Access Compliance Report

Public Rights-of-Way

(Curb Ramps)

Intersection ID: 52929	Main Street: ENGLISH_OAK_LEAF_CT	Cross Street: GRAY_OAK_LN	Location: W
ADA ID: 4C11272B6861	Ramp Type: Perp	Initial Pass/Fail: Fail	Overall Compliance: No
Severity Score: 8.75			
Codes/Mitigation Info/Possible Solution		Field Measurements/Component Compliance

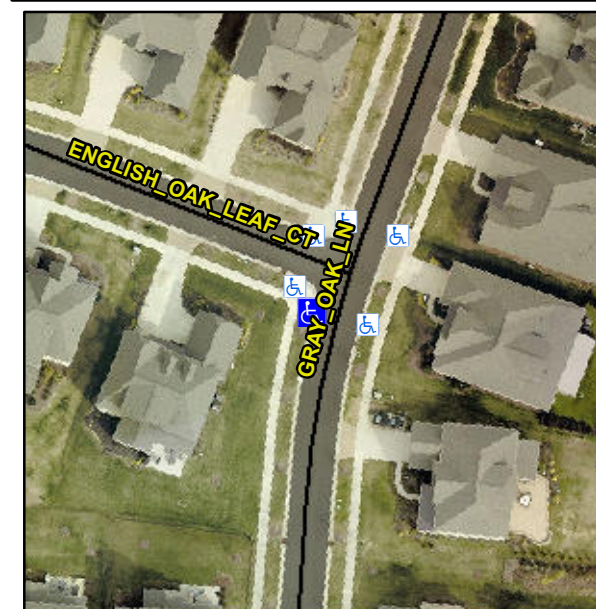
Not Found, R304.5.1

Compliance	Description	Data	Compliance	Description	Data
N/A	Ramp Length (in)	97.0	Yes	Ramp Slope (%)	7.3
No	Ramp Width (in)	47.5	Yes	Ramp XSlope (%)	1.7
N/A	Flare Type LT	N/A	N/A	Flare Type RT	N/A
N/A	Flare Slope LT (%)	N/A	N/A	Flare Slope RT (%)	N/A
N/A	Flare Traversable LT?	N/A	N/A	Flare Traversable RT?	N/A
N/A	Landing Length (in)	N/A	N/A	DWS Provided?	N/A
N/A	Landing Width (in)	N/A	N/A	DWS Contrast?	N/A
N/A	Landing Slope (%)	N/A	N/A	DWS Length (in)	N/A
N/A	Landing X Slope (%)	N/A	N/A	DWS Full Width?	N/A
N/A	Landing Curb? (Y/N)	N/A	N/A	DWS Offset (in)	N/A
N/A	Shared Landing?	N/A			
N/A	Gutter Ponding?	N/A	N/A	Gutter Slope (%)	N/A
N/A	Gutter Lip Ht (in)	N/A	N/A	Gutter X Slope (%)	N/A
N/A	Painted X Walk1?	No	N/A	Painted X Walk2?	N/A
	X Walk 1 Direction	To E		X Walk 2 Direction	N/A
N/A	X Walk 1 Width (in)	N/A	N/A	X Walk 2 Width (in)	N/A
	X Walk 1 Slope (%)	2.6		X Walk 2 Slope (%)	N/A
	X Walk 1 X Slope (%)	2.5		X Walk 2 X Slope (%)	N/A

Remove & Replace Entire Ramp.
